ATTACHMENT K

**ENGINEERING GEOLOGIC &
GEOTECHNICAL INVESTIGATION
4-LOT RESIDENTIAL DEVELOPMENT
ZMAY PROPERTY
1551 CRYSTAL SPRINGS ROAD
SAN MATEO COUNTY, CALIFORNIA**

**RE: SUPPLEMENTAL EVALUATION &
RESPONSE TO REVIEW COMMENTS,
ZMAY PROPERTY,
1551 CRYSTAL SPRINGS ROAD,
SAN MATEO COUNTY, CALIFORNIA**

SITE PLAN & ENGINEERING
GEOLOGIC MAP

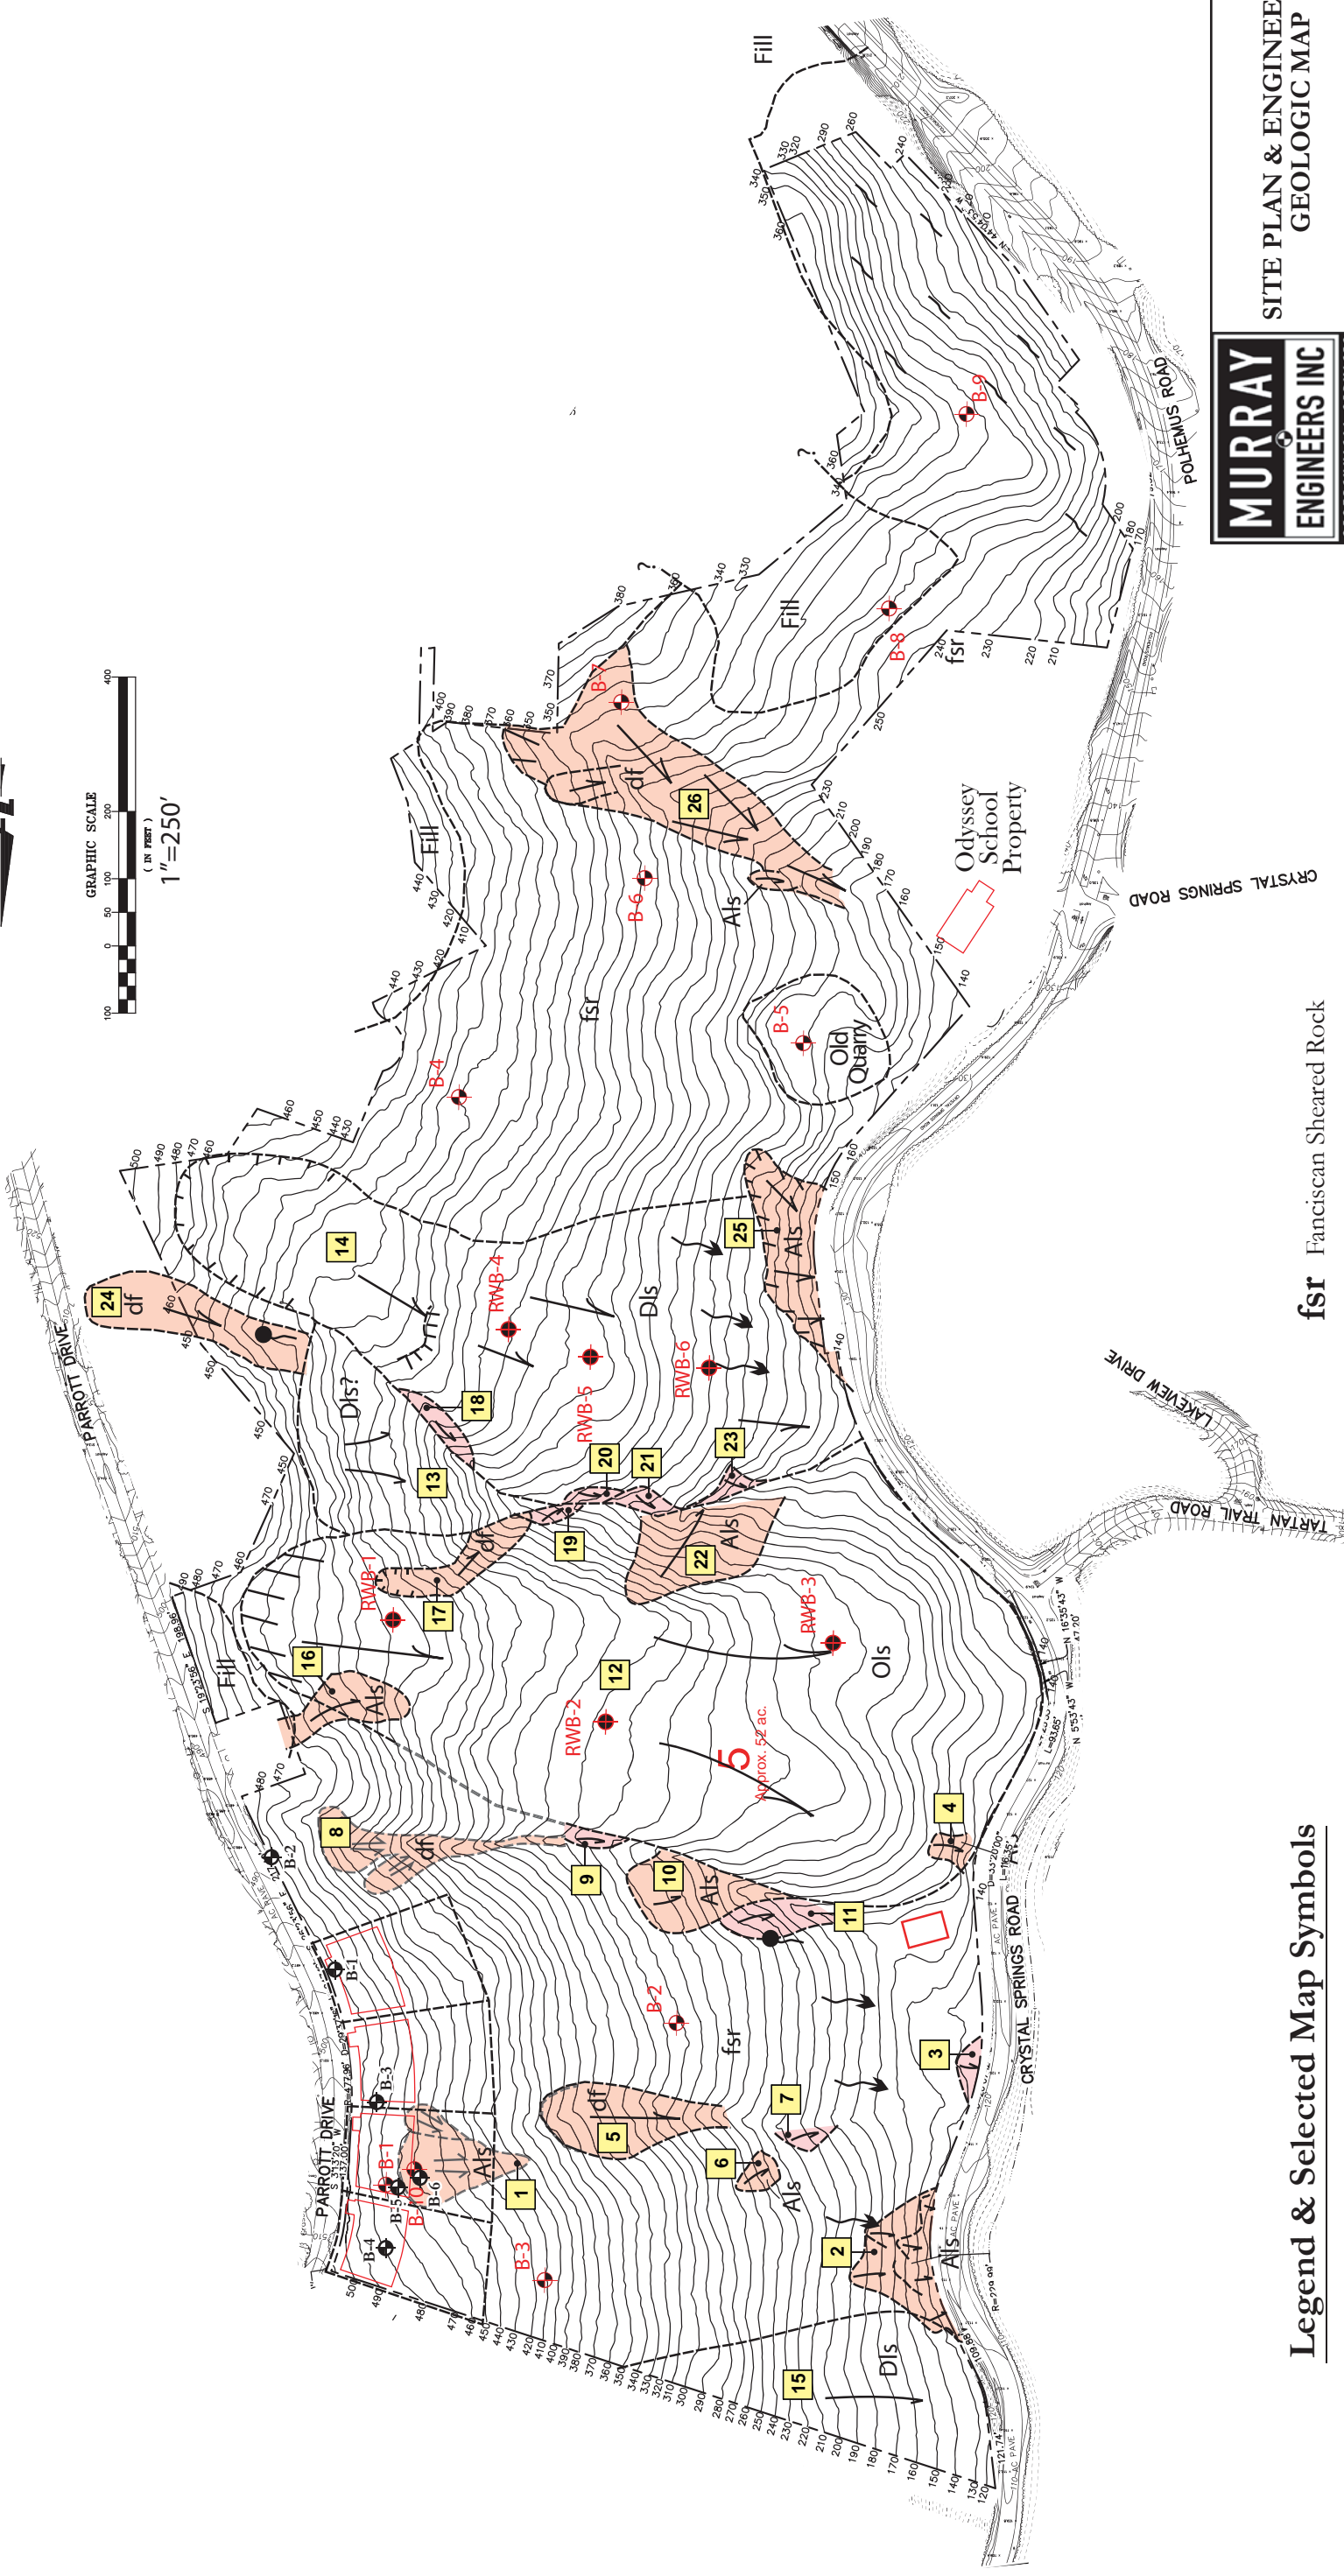
- A) The approximate area for stabilization repair of active landsliding within Parcels 1 and 2 should be depicted in plan view and cross section. Conceptual design measures should be presented that are intended to prevent future reactivation or enlargement of landsliding across the common property line. If a grading repair is selected, approximate grading volume estimates should be prepared.*

Based on the reconfiguration of parcel boundaries, the majority of the mapped active landslide is located within Parcel 2. Please refer to Figure 1 for the reconfiguration of the proposed parcel lines and refer to Cross Section B-B' (Figure A-7) of MEI's 2014 report for reference. We understand that the project civil engineer will be providing a cross section depicting the proposed landslide repair, including keying and benching details of the fill, fill subdrainage, and grading volumes.

The reconfiguration of the proposed parcel boundaries results in four smaller parcels with slopes that are no steeper than the previous locations of parcels 1 through 3. Specifically, the parcels have been shifted away from the debris flow and steep ravine mapped south of the newly proposed parcel 4. Please refer to our attached site plan for further clarification.
